## Staff Report

**From** Kelly O'Neill, Development Services Director  
21-018 AP 38797 & 38799 Creekside Loop Garage Setback

**SUBJECT:** Adjustment Second Appeal

**FINDINGS OF FACT and FINAL ORDER  
TYPE I and II ADJUSTMENT**

**SITE PLAN**

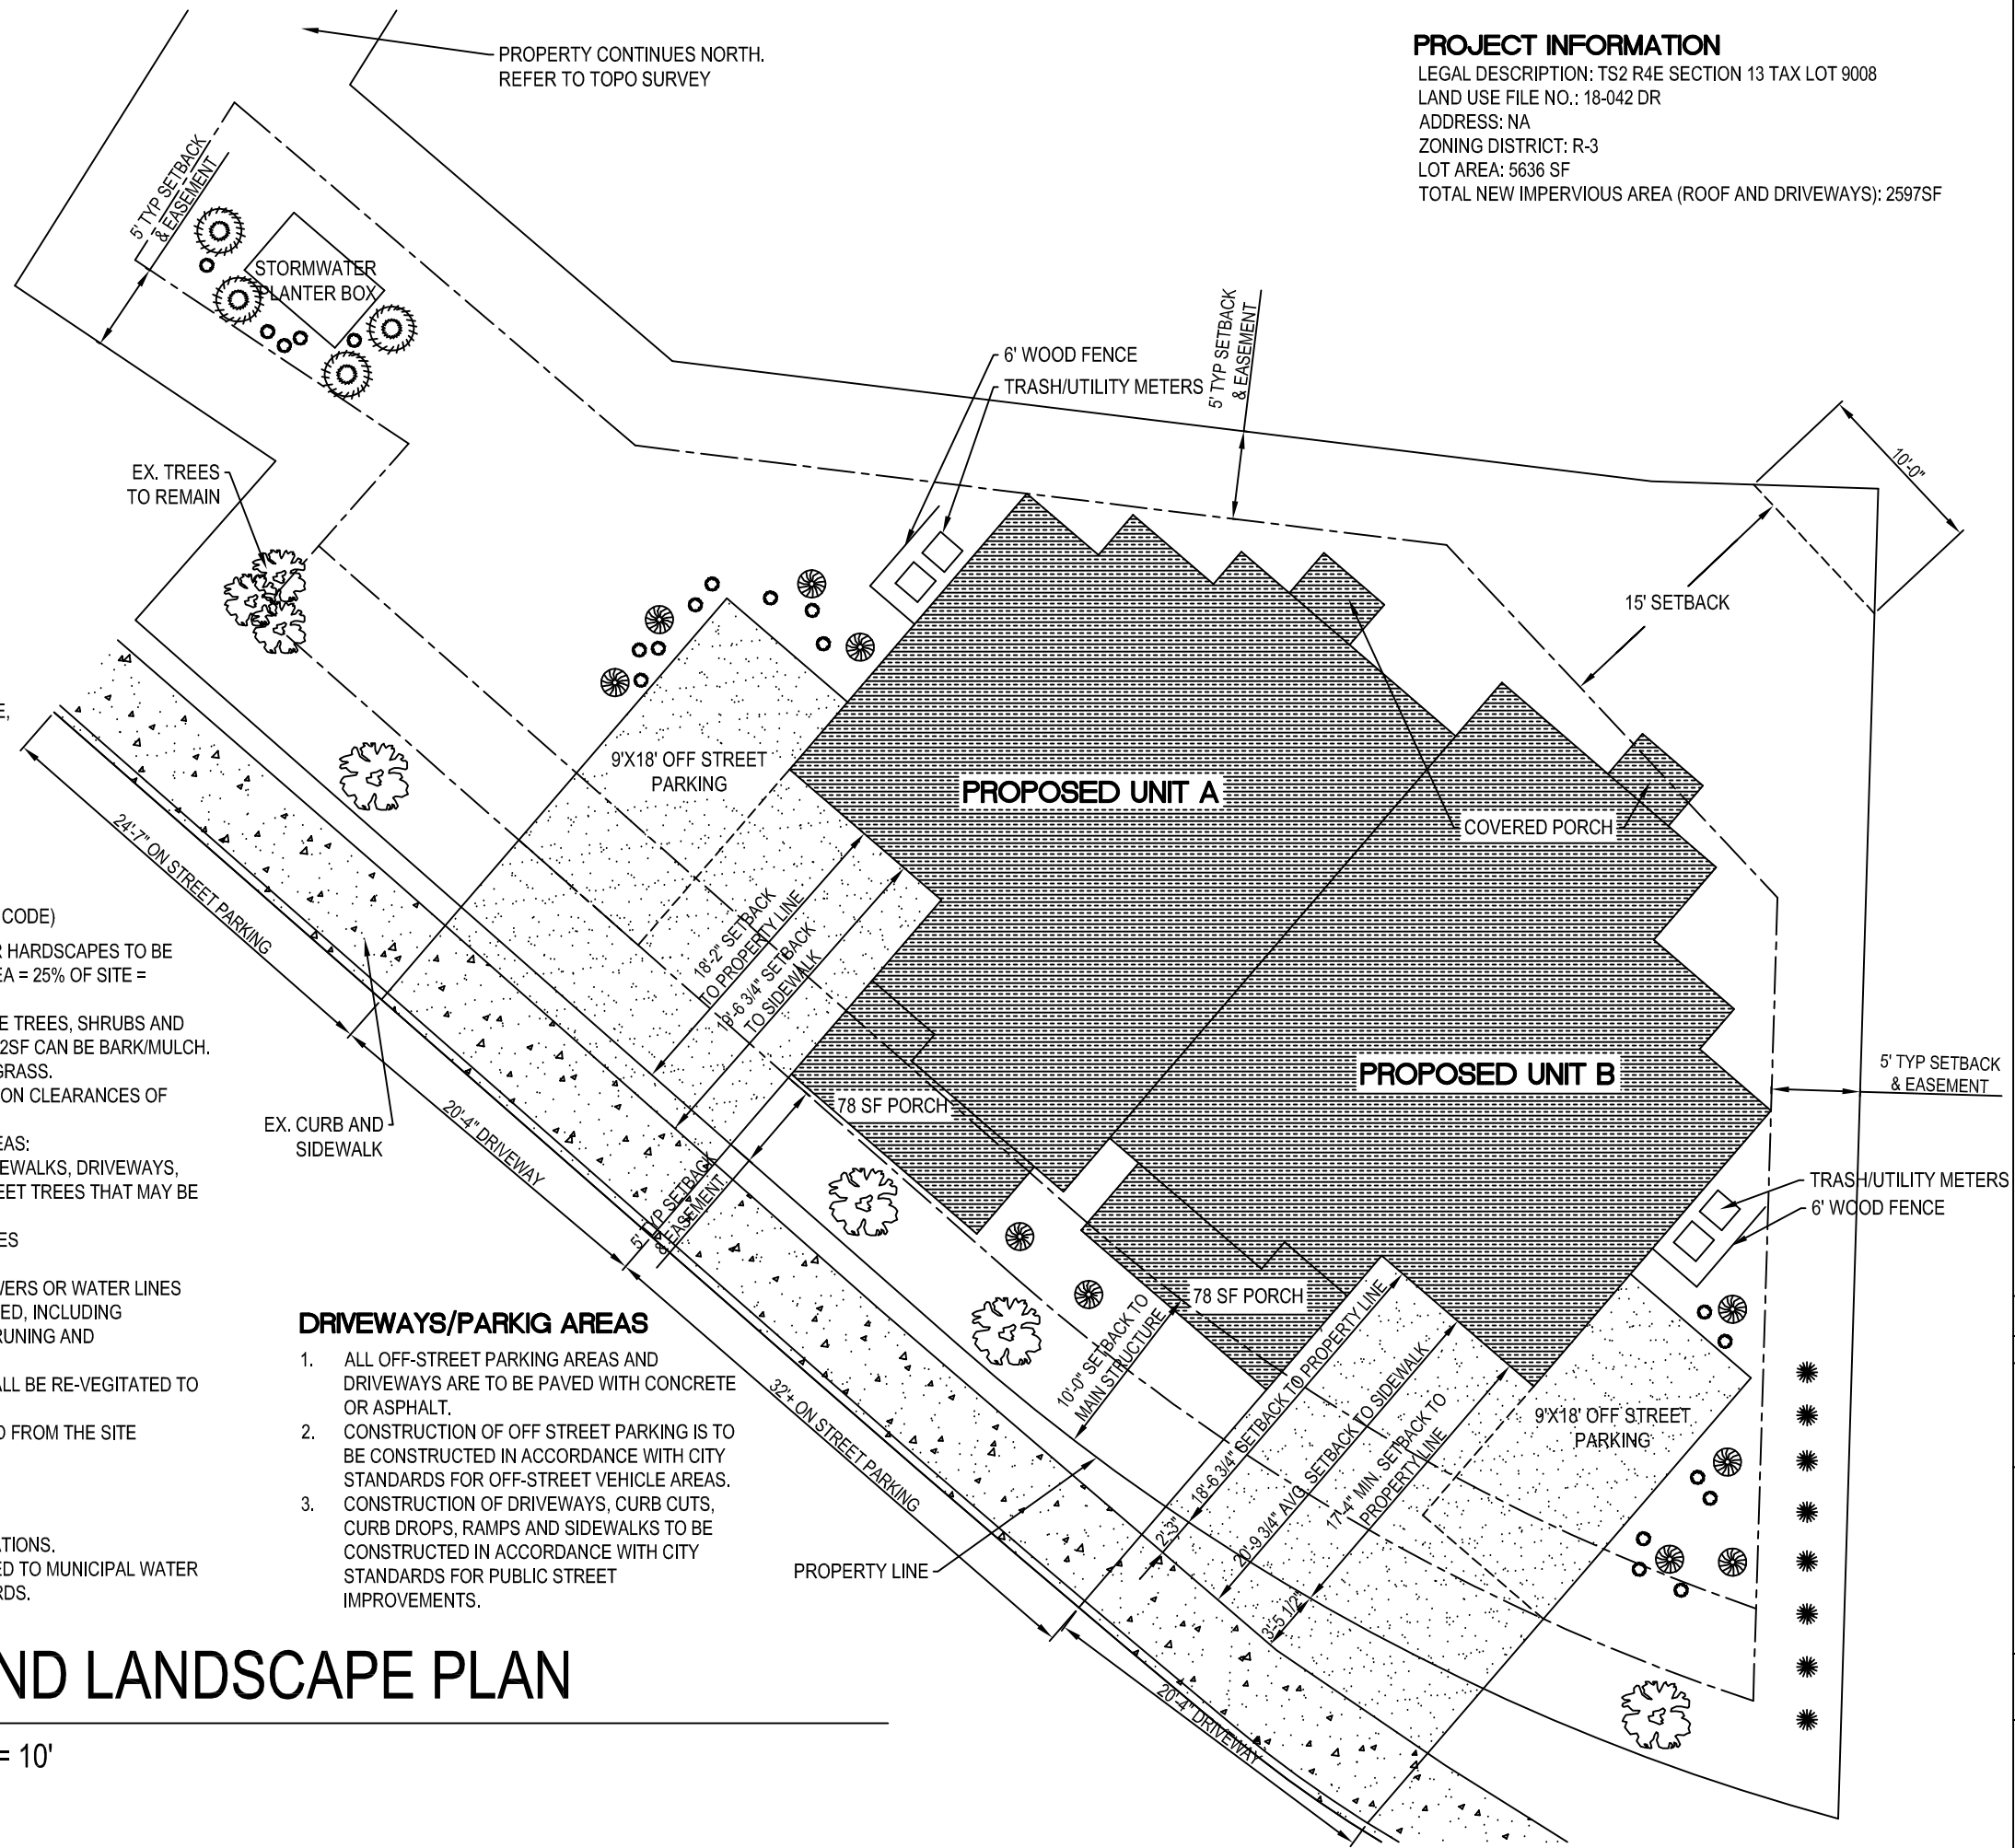
4. With this application (File 20-049 ADJ), the applicant submitted a revised Site Plan (Exhibit C) that details the garage setback for Unit A (the western unit) at 18 feet 2 inches and the garage setback for Unit B (the eastern unit) at 17 feet 4 inches, both of which can be processed as adjustments. Therefore, a variance request is not necessary.

14. Per the submitted narrative (Exhibit B) and Site Plan (Exhibit C), the applicant is requesting an adjustment to reduce the required garage setback for the duplex from 20 feet to 18 feet 2 inches for Unit A and 17 feet 4 inches for Unit B. The proposed reduction to 18 feet 2 inches is a reduction of 1 foot 10 inches (1.833 feet), which is a 9.2 percent reduction from the required 20 foot garage setback and can thus be processed as a Type I Adjustment. The proposed reduction to 17 feet 4 inches is a reduction of 2 feet 8 inches (2.666 feet), which is a 13.3 percent reduction from the required 20 foot garage setback and can thus be processed as a Type II Adjustment.

The adjustment being proposed in File 20-049 ADJ, poses a concern for vehicle traffic and parking on Creekside Loop. Reducing the 20-foot garage setback required per Code Section 17.40.30 creates a condition where the occupants will not be able to park vehicles in front of the garage without partially obstructing the sidewalk.

- a. The applicant shall update the site plan to detail the garage setback for Unit B at 18 feet minimum.
  - b. The applicant shall either design the driveway approaches such that the 20 foot 4 inch widths include the wing lengths or shall update the Site Plan to reflect the actual on-street parking area that remains after the wings are subtracted. This shall include the length from the west property line to the edge of the west wing of the driveway for Unit A, the length from the edge of the east wing of the driveway for Unit A to the edge of the west wing of the driveway for Unit B, and the length from the edge of the east wing of the driveway for Unit B to the east property line.
